**Project:** Site C - Crows Nest Station

**Report:** Updated BCA and Access Assessment Report

**Reference No:** SMCSWSCN-SMC-SCN-EM-000019

**Date:** 15 March 2021

Figure 28 in AS1428.1-2009

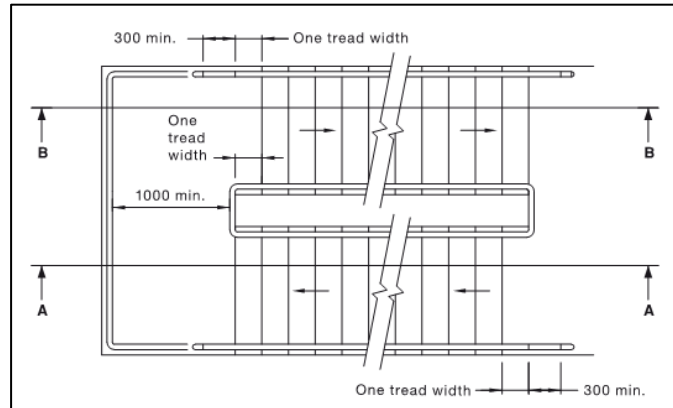
As currently documented - offset stair flights will enable handrail compliance with above. Further assessment required at Crown Certificate Stage
